BRL SIS (Sales Information Service)

PB-MGE05-06 US

Product Bulletin – Aluminum Structural Framing**45° Angle Connector in a Uniform Design**

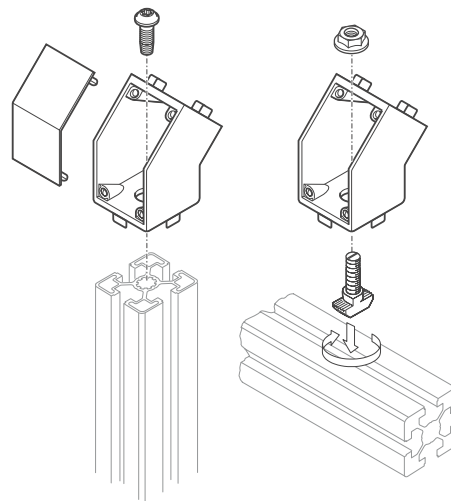
Introducing the new 45° angle connector, part no. 3842 535 428, designed for the 45 mm profile. Made from diecast aluminum, the new connector matches the design of models for 30 and 40 mm profiles. This new unit replaces part no. 3842 518 425 and will be the direct replacement for the old connector which is being phased out.

NEW 45°
Angle Connector
3842 535 428

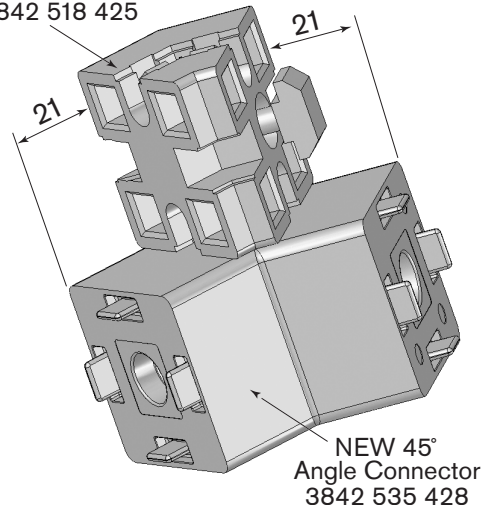
Each leg of the new 45° Angle Connector is approximately 21 mm longer than the old style connector that it replaces
